**Development Special Use Permit #2010-0028****TMP Special Use Permit #2011-0002****The Madison (Amendment to DSUP #2007-0005)**

Application	General Data	
<b>Project Name:</b> The Madison	PC Hearing:	February 1, 2011
	CC Hearing:	February 12, 2011
	If approved, DSUP Expiration:	February 12, 2014 (3 years)
<b>Location:</b> 800 – 840 North Henry Street	Zone:	CRMU-H
	Proposed Use:	Multi-family and Retail
<b>Applicant:</b> EQR – Madison & Henry, LLC, represented by Duncan Blair	Small Area Plan:	Braddock Road Metro
	Historic District:	No
	Green Building:	Will conform to the City's Green Building Policy

**Purpose of Application**

Original 2007 Approved Open Space Plan

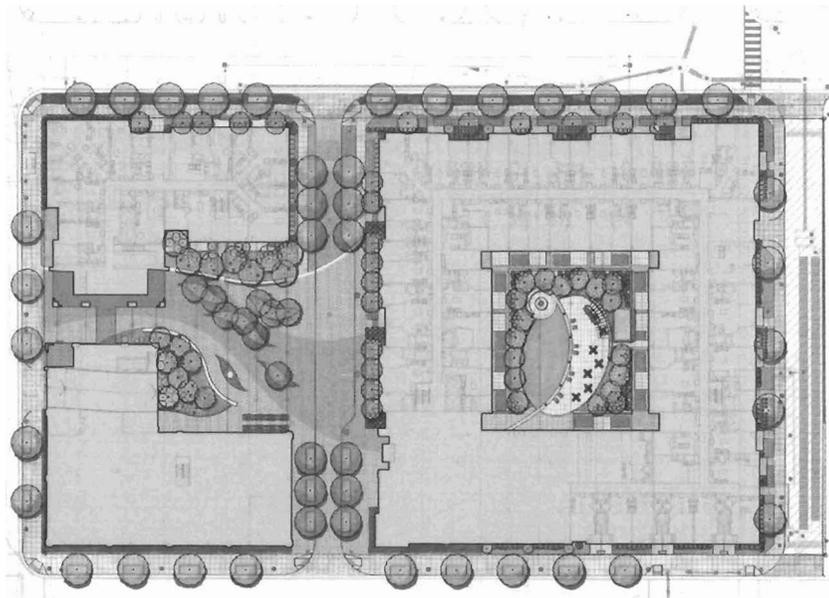
The design of the two courtyards have been revised to make them not only more attractive but more functional as well. The southern courtyard, which will retain a public access easement, has been improved by making the usable area all at the same grade as opposed to the previous plan which included terraced areas. Also, the planting areas have been

The northern courtyard has been improved with added landscaping and also enlarged by an additional 1,556 square feet to make it a more attractive amenity for the units that face onto it. Additional seating areas, an artificial turf area to sit on and an outdoor service bar for outdoor functions have been added. *(See attached drawings for revised open space plans)*
